ADDENDUM NO. 7

**Federal Aid Project No. STP/CMQ/HSI-0034(030)X
Reconstruction on Route 38 (Main Street), from Route 62 to the Woburn C.L.**

PLANS: Revised sheet 228 of 394.

Question and Response

PRECAST CONCRETE MEDIAN BARRIER (TL-3) - DOUBLE FACED

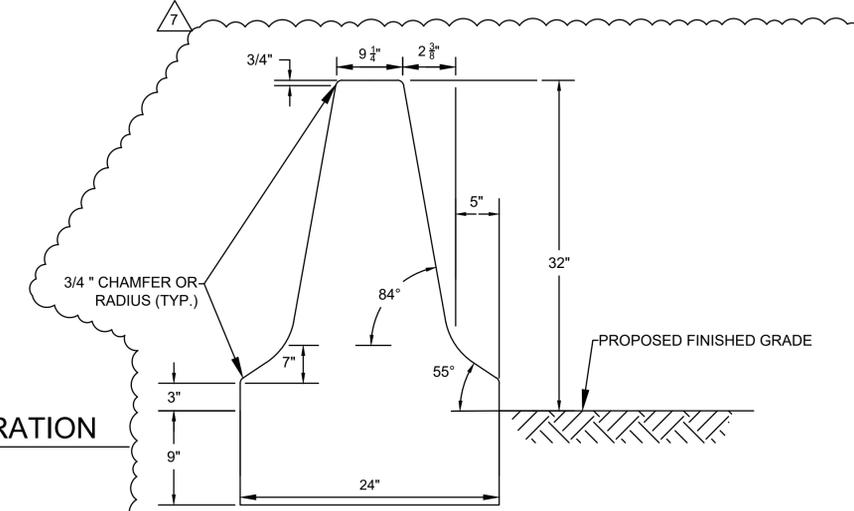
Question 59) Please provide a detail for Item 629.2 – Precast Concrete Median Barrier – Double Faced.

Revised Response 59) See the revised Plans Sheet 228 of 394. The Contractor shall submit shop drawings for the barrier system demonstrating TL-3 performance for review and approval in accordance with the Contract requirements.
